Final Response to Government Agency Submissions and Non- Confidential Public Submissions

Calga Sand Quarry Southern Extension

Major Project Application No.
06_0278

Submitted: November 2012

DECCW Submission – Page 5

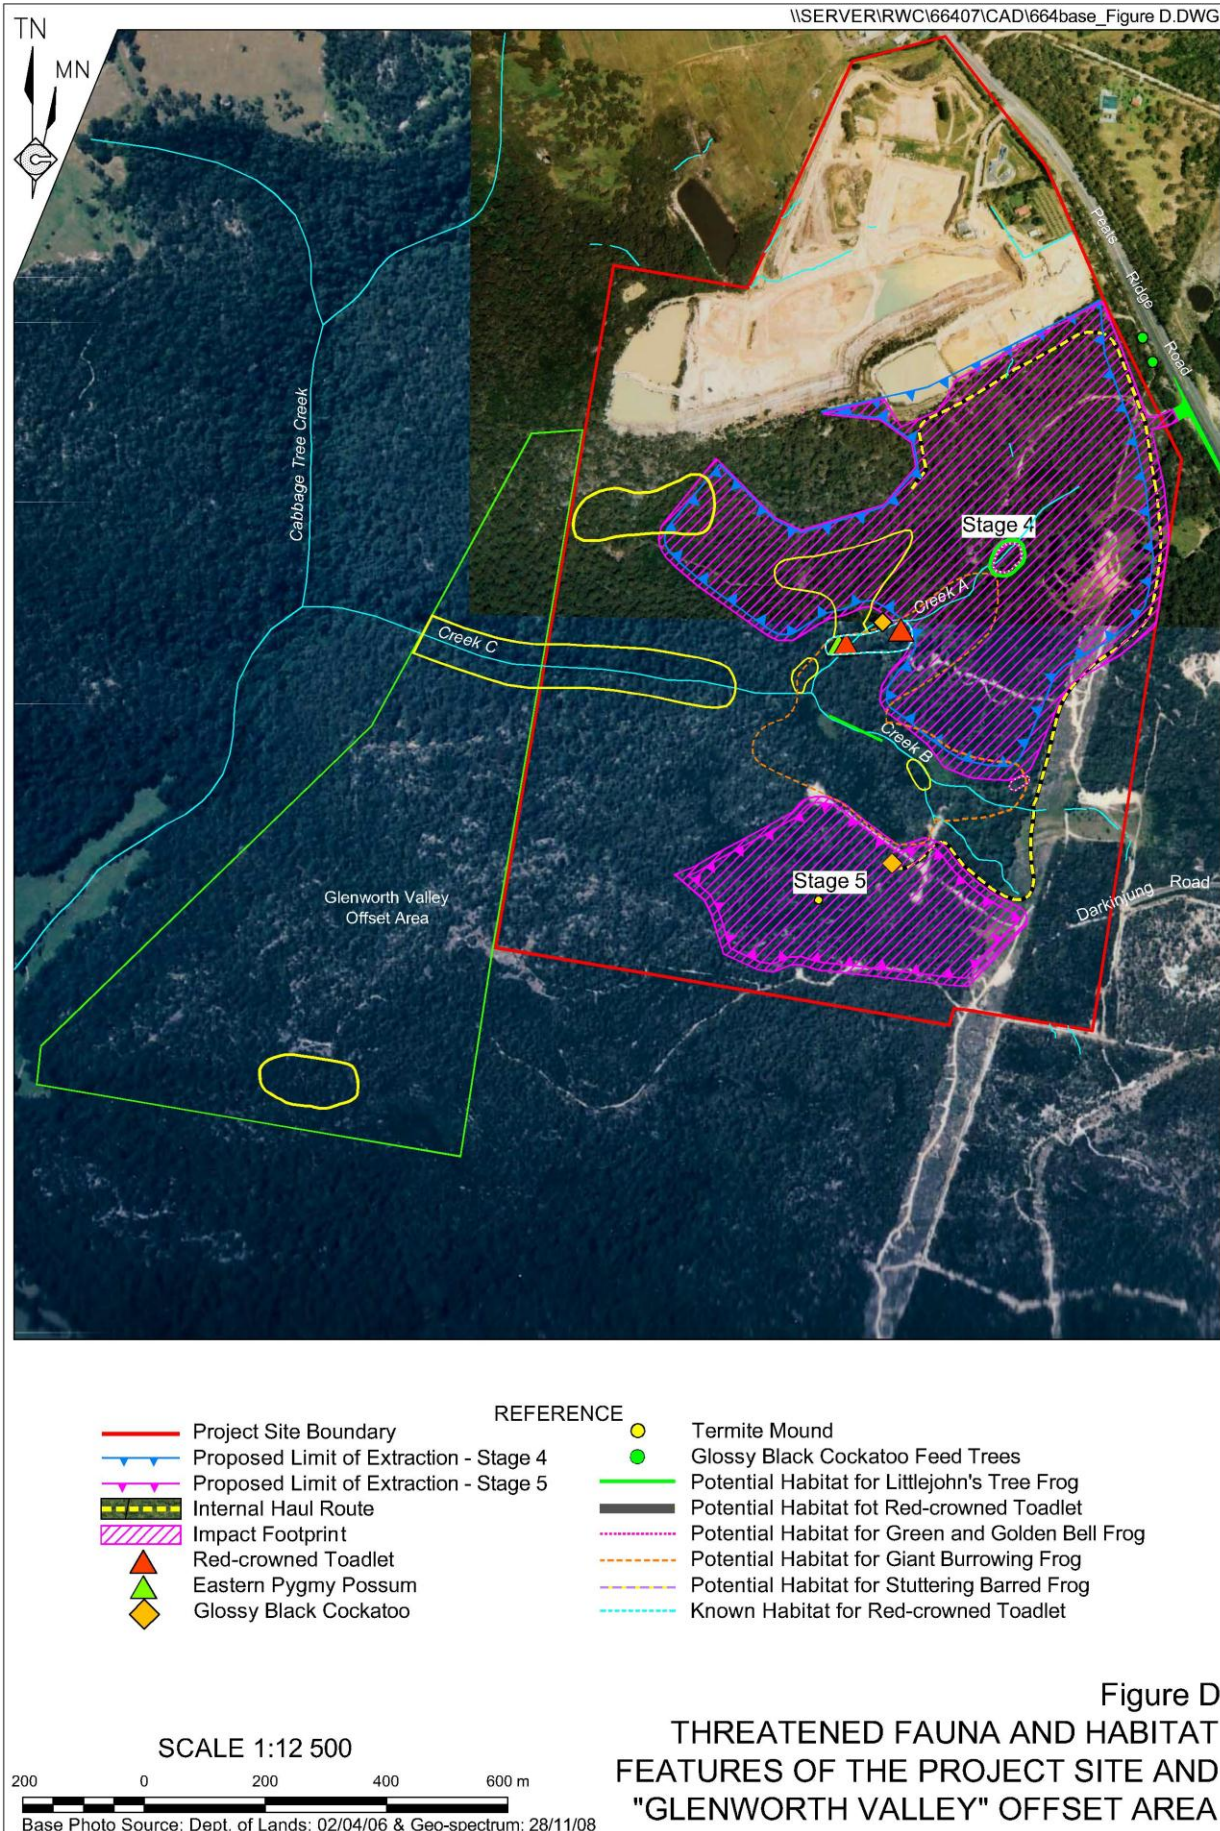
Given the above issues DECCW is of the view that the offset needs to be supplemented to address likely impacts on amphibians.

Although the DECCW survey only detected the Red-crowned Toadlet at one location, the DECCW survey was only undertaken on one day in January 2010. Further surveys are likely to have yielded additional records of this species.

As identified within Figure 3.3 of Cumberland Ecology's Offsets Report (**Attachment 3**), a number of areas containing potential habitat for the Red-crowned Toadlet occur within the proposed offset areas and are known to occur in the Popran National Park.
